UNITED STATES OF AMERICA
NUCLEAR REGULATORY COMMISSION

(Allens Creek Nuclear Generating
Station, Unit 1)

Docket No. 50-466

NRC STAFF'S PARTIAL RESPONSE TO
JOHN F. DOHERTY'S FOURTEENTH SET OF INTERROGATORIES

Figure 34

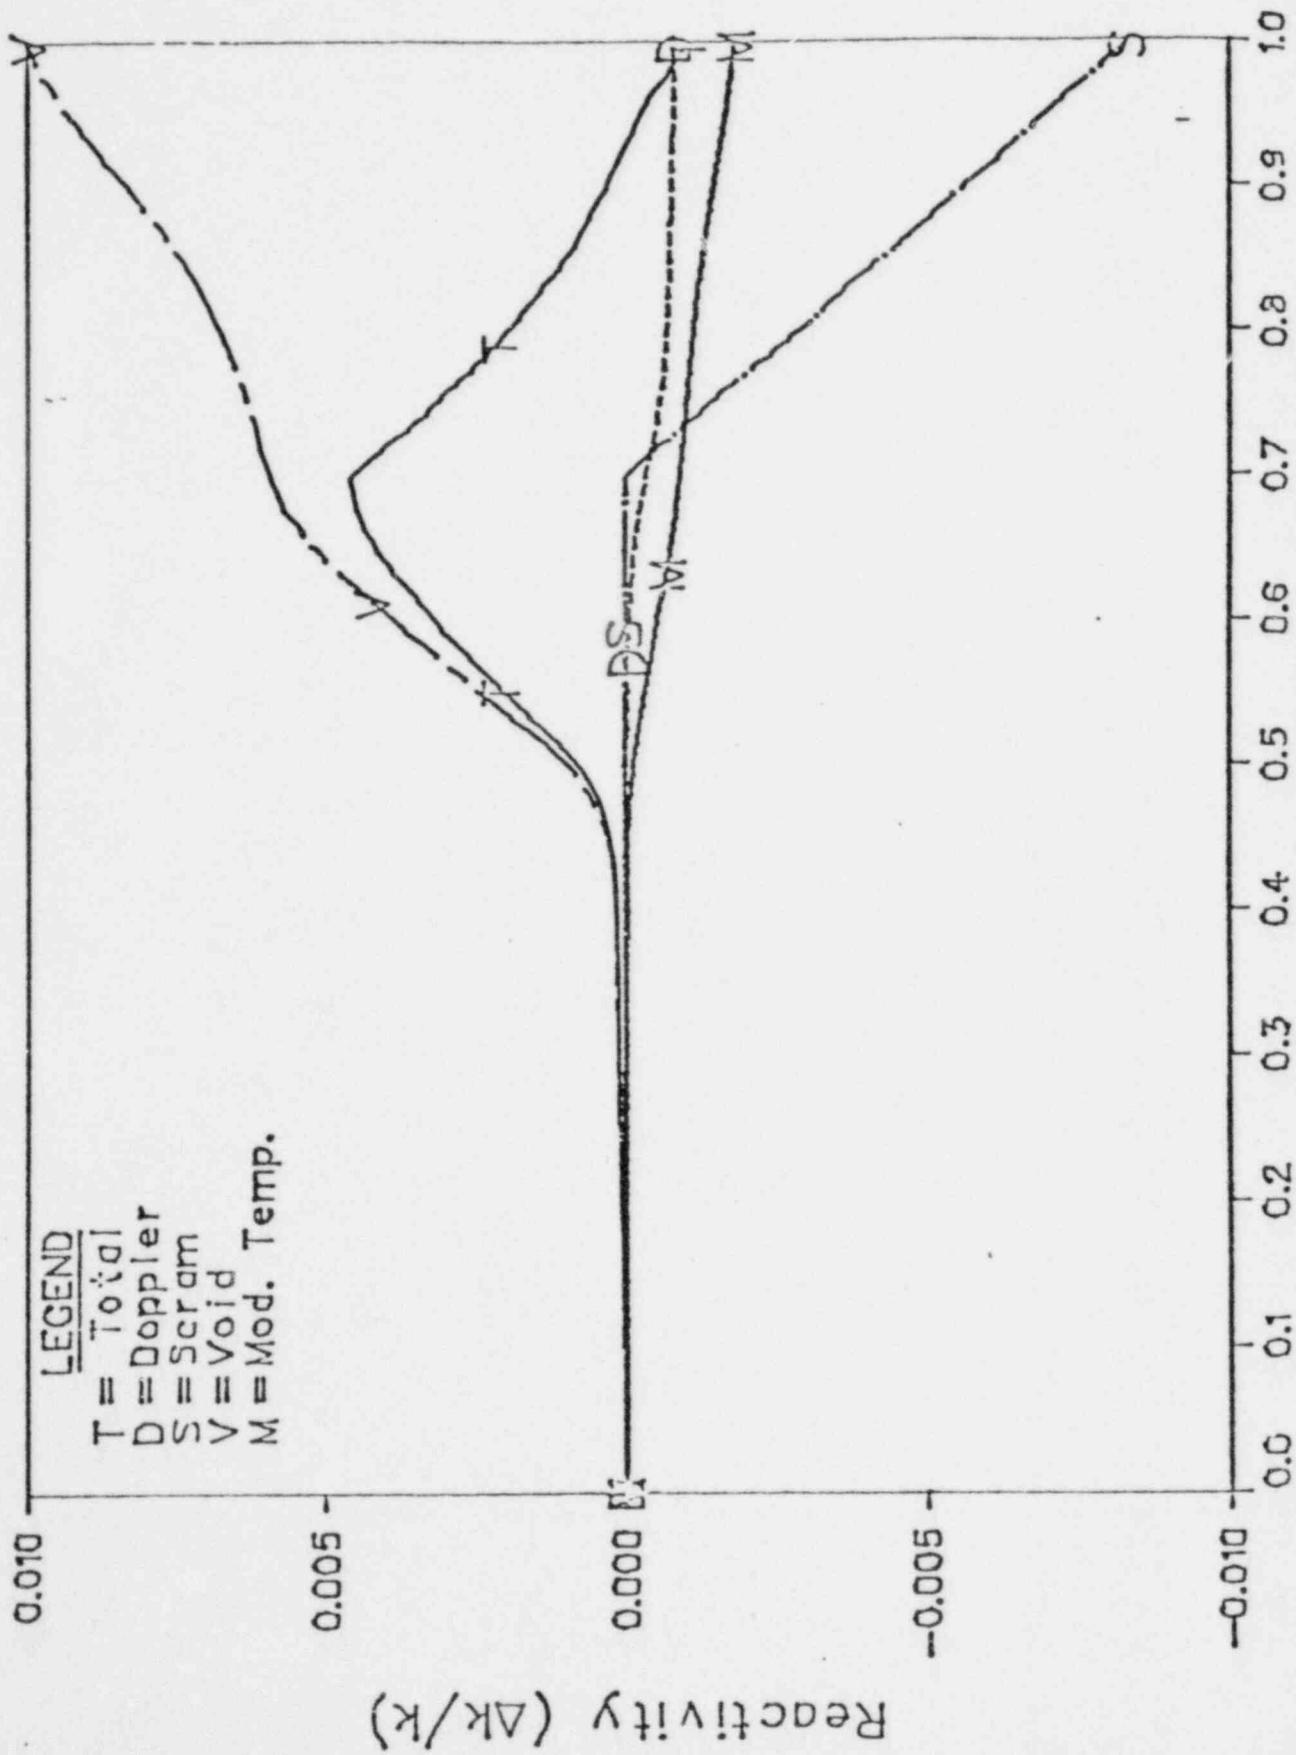
15. In an overpressurization transient without temperature increase in the core what is the gross effect on Doppler reactivity? Relevant to Doherty 33.

In an overpressurization transient without temperature increase in the fuel there would, of course, be no reactivity feedback due to Doppler. However, no fuel temperature increase implies no power increase. In any event the Doppler effect plays a relatively minor role in overpressurization transients (See attached Figure, taken from BNL-NUREG-26689, Sept. 1979).
